July 3, 2025

PROJECT NAME: JUNIPER LOOP DEVELOPMENT

PROJECT NUMBER: 2024040016

APPLICATION: REZONING TO PUD WITH CONCEPT PLAN #32940

P.U.D. CONCEPT PLAN
JUPITER LOOP FKA CHESTNUT HILL
MARION COUNTY, FLORIDA

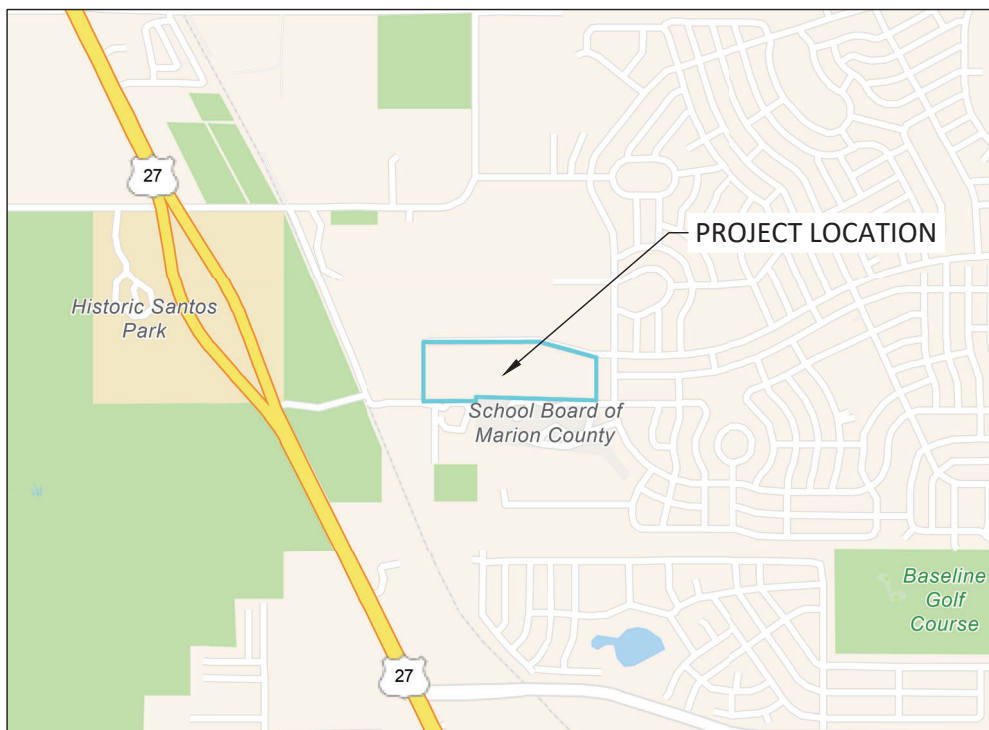
REMARKS: Concept plan is sheet 03. This is not a master plan submittal.

REMARKS: [1] Overlay zones were omitted. Add Primary Springs Protection Overlay Zone to the next submittal.

[2] Open space / amenity uses were omitted from the "proposed use" section of site data on 03 Concept Plan.

[3] Max building height listed is 50' which is 10' higher than allowed under standard R-1 zoning.

[5] Tracts are not labeled.

[1] On 03-Concept Plan, add 15' min side street setback, consistent with what is shown on 06-Typicals and listed on 05-A-Site Data.

[5] Calculations for open space on 03 Concept Plan are not consistent with calculations for 11-Open Space Map. Make the calculations consistent for the next submittal.

REMARKS: Location of water/sewer facilities not shown, but 03-Concept Plan states City of Bellevue as the Water and Sewer provider.

- 44 DEPARTMENT: 911 - 911 MANAGEMENT
REVIEW ITEM: Rezoning to PUD with conceptual plan
STATUS OF REVIEW: INFO
REMARKS: APPROVED - New road names will be issued on future plat submittals. Sheets 03, 13 & 14 have Juniper Road incorrectly labeled as NW Juniper Rd. Be sure to correct the road name and remove "NW" on future submittals.

SHT. 05-F

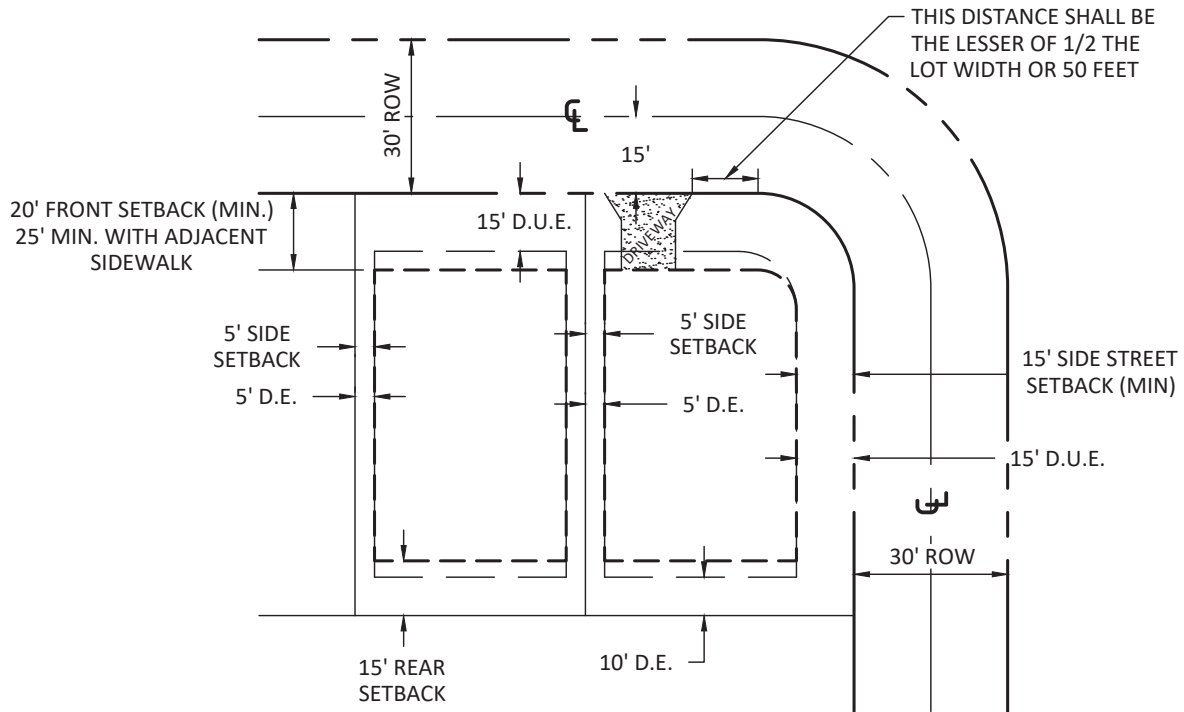
REMARKS: Shown on 05-Flood zone map. FEMA flood zone X and scattered portions of Marion County Flood Prone Area are being converted to DRAs per 03 Concept Plan.

30' PRIVATE RIGHT-OF-WAY ROADWAY SECTION

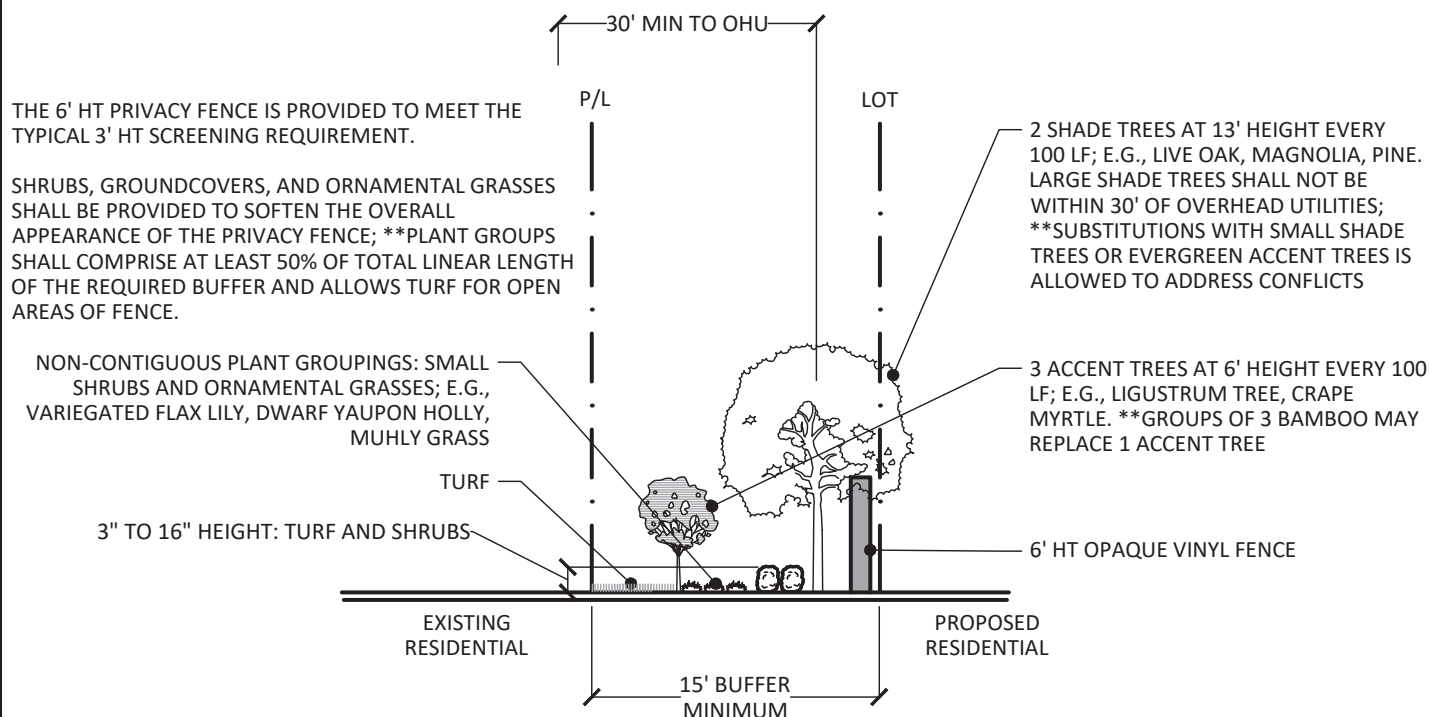
The PUD plan shows that the internal roadways are proposed to have 30 feet of right-of-way with 15' easements on each side. This should be left for review by the Development Review Committee to review and approve any necessary waivers.

BUFFER DETAILS

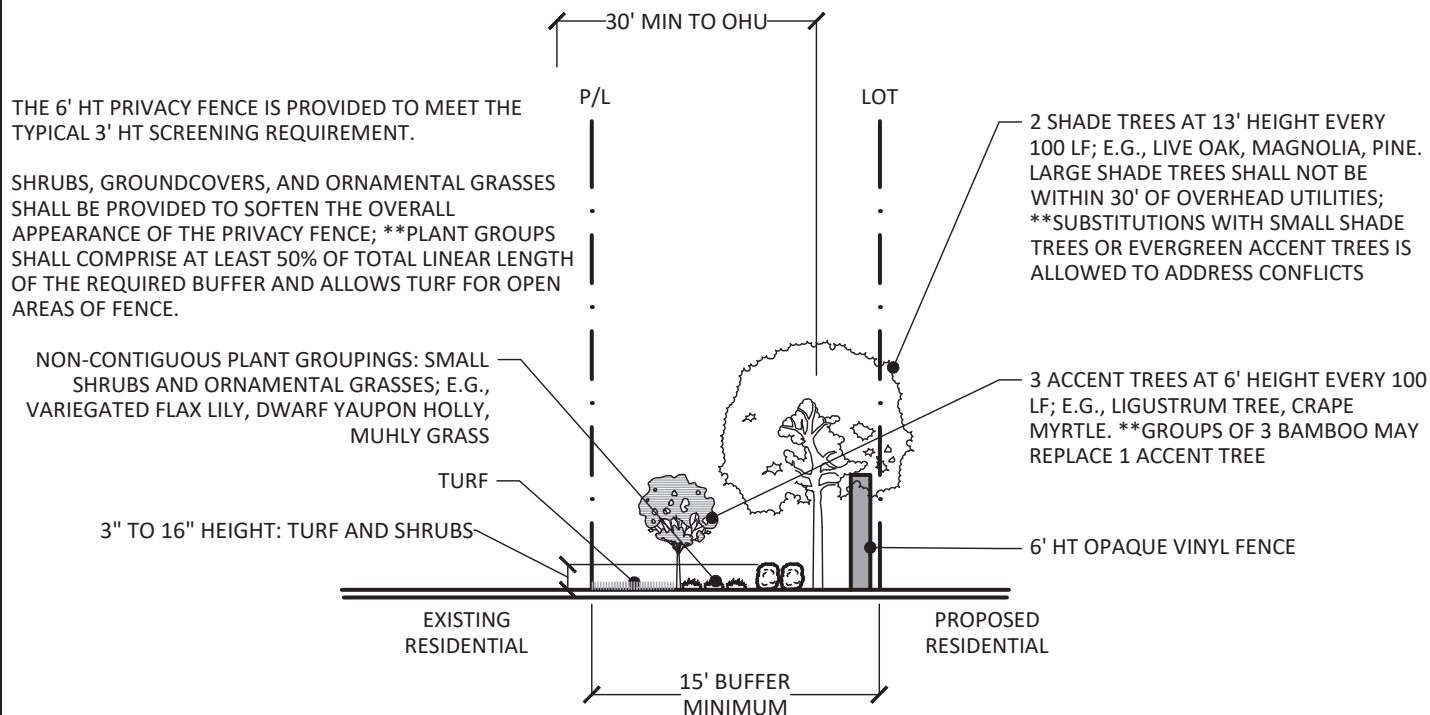
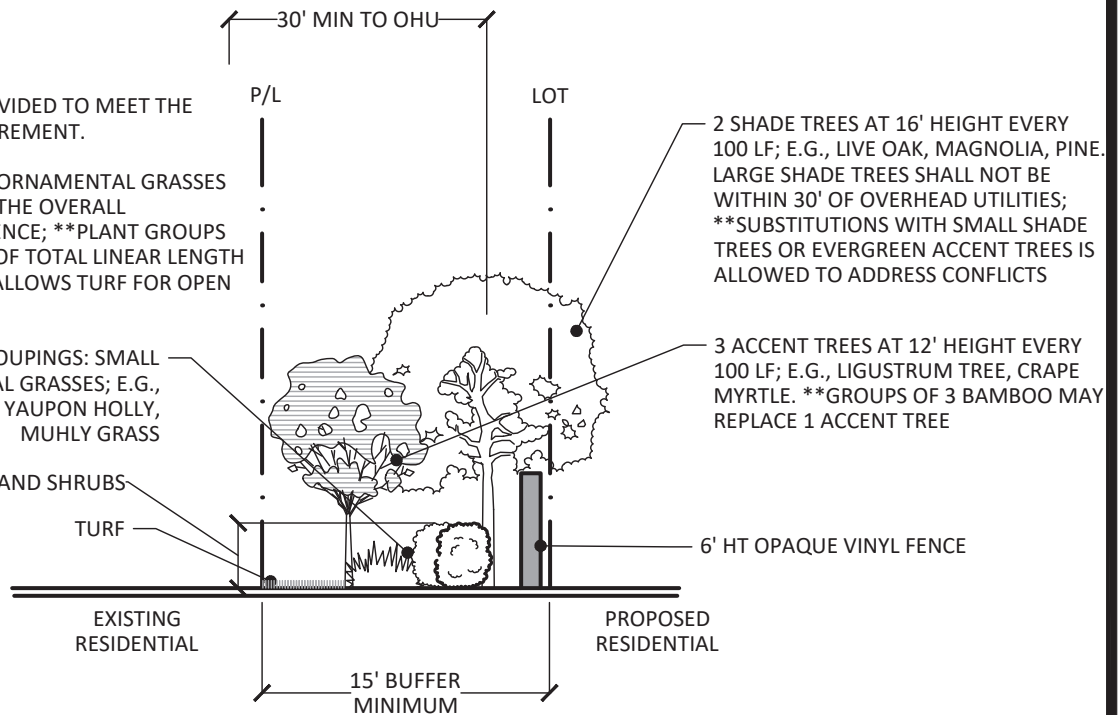
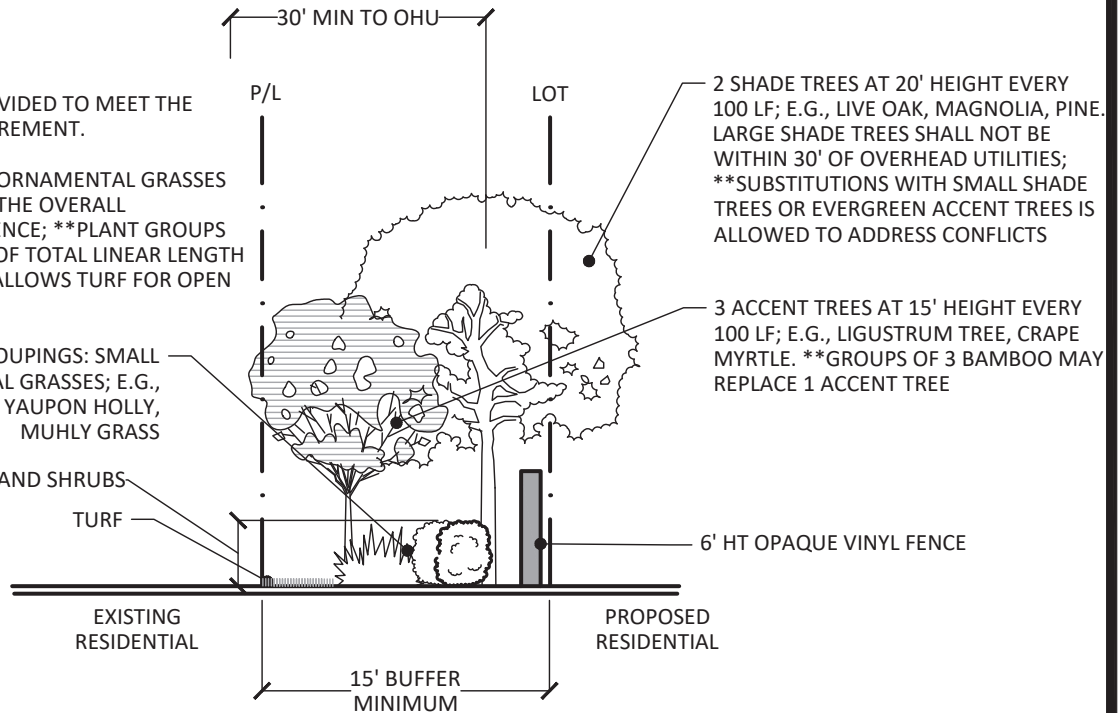
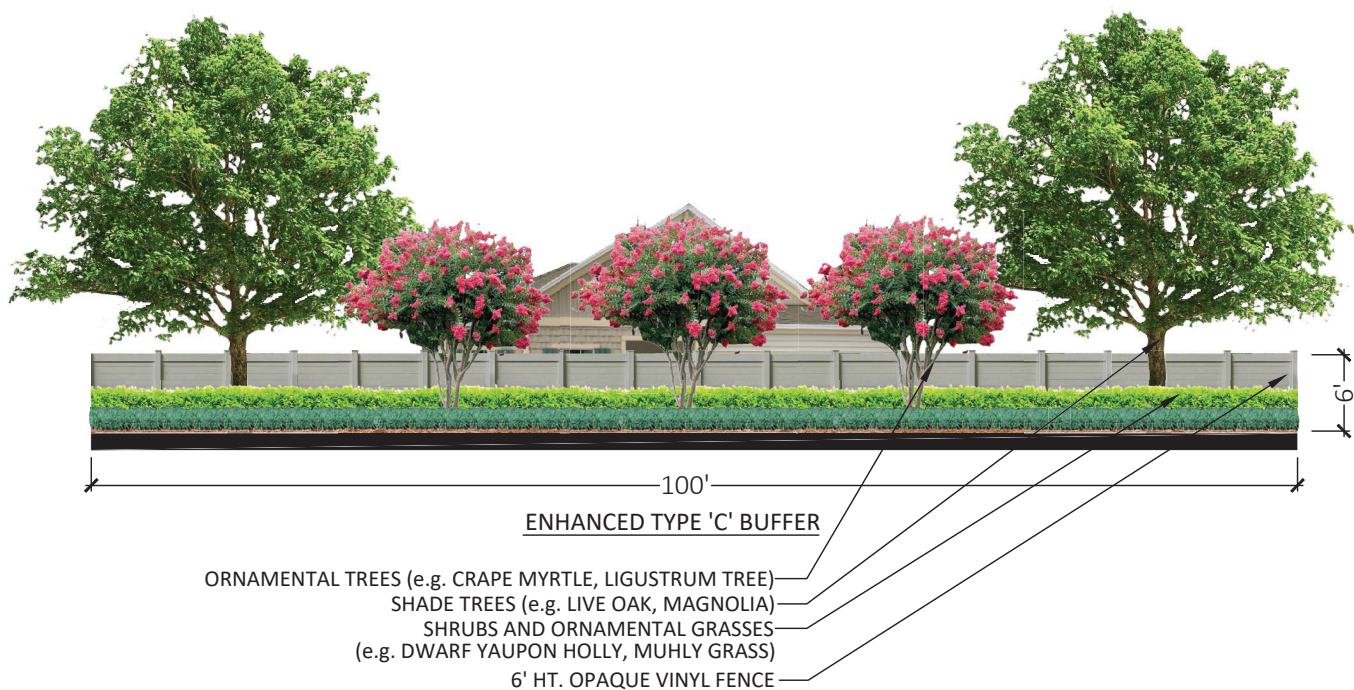
REMARKS: Modified Type C buffer fits the intent of buffering SFR to existing School (Public use) and exceeds the intent of SFR buffering to existing Agricultural properties to the north.

For next plan submittal, show colored renderings of what the buffers will look like Modified Type C and Enhanced Type C buffers will look for installation, year 1, year 3, and year 5.

OPEN SPACE MAP AND CALCULATIONS

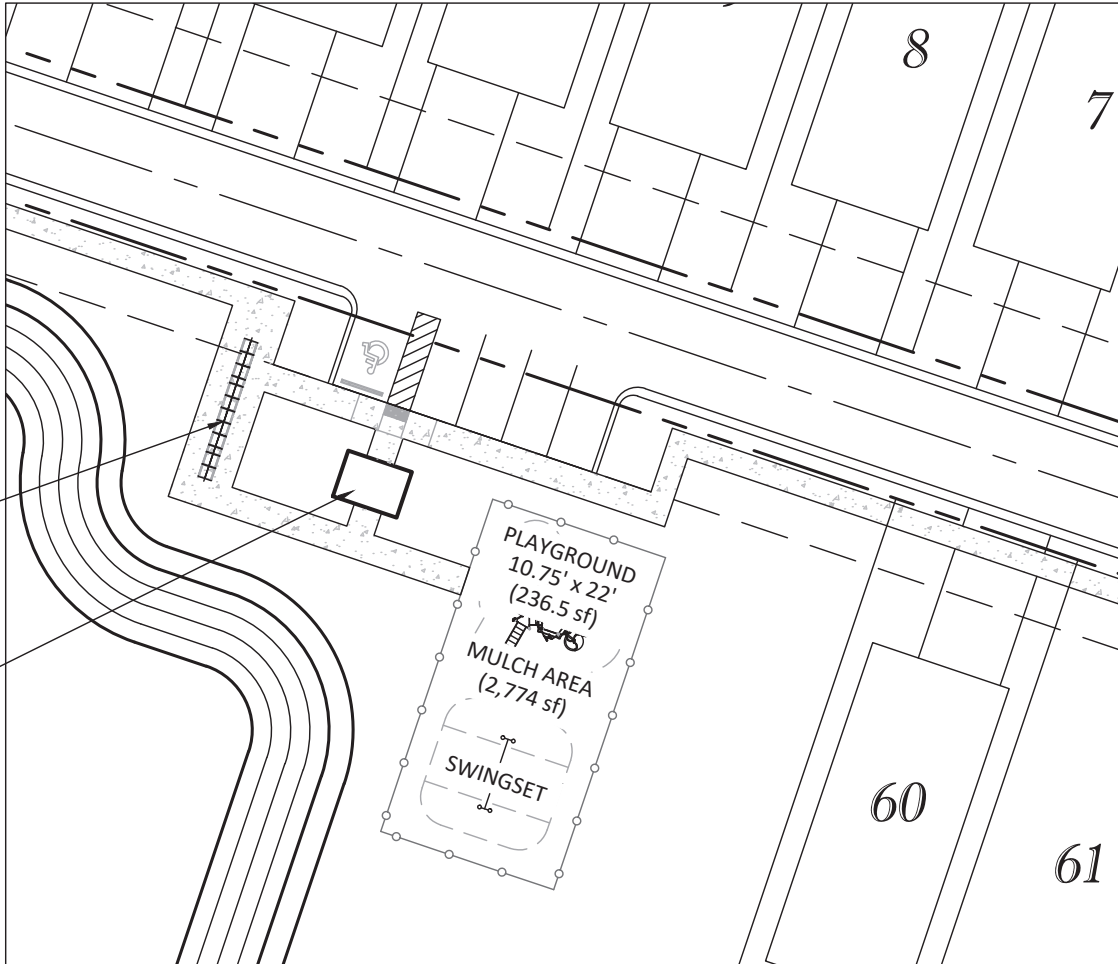
11-Open Space Map seems to have several inaccuracies.

[1] There is a portion of open space (shown in green) along the northern boundary that protrudes south into the interior of the site. This does not match the lot configuration shown on the concept plan (see area between lots 19 and 30). Adjust the concept plan or open space map as needed in the next submittal. State which one was changed.

[2] The pale yellow color in the key for improved open space seems to correspond with private yards for the proposed lots. The tan color, which is not included on the key, seems to correspond with improved open space. Clarify the key in the next submittal.

[3] Why is only a portion of the walking trail made of grass shown as improved open space? Per code 6.6.6.B(1) "Improved Open Space may include active and passive parks and recreation facilities... and outdoor areas." The grass walking trail would be part of a park and outdoor area for community use. Revise accordingly in next plan submittal.

[4] The DRA is shown as 1.23+- AC (25% of 14.68AC). Why? The total provided open space is listed as 14.25. Please re-run your calculations for the next submittal and fix inconsistency. Consider adding a breakdown of modified type C buffers and enhanced type C buffers.
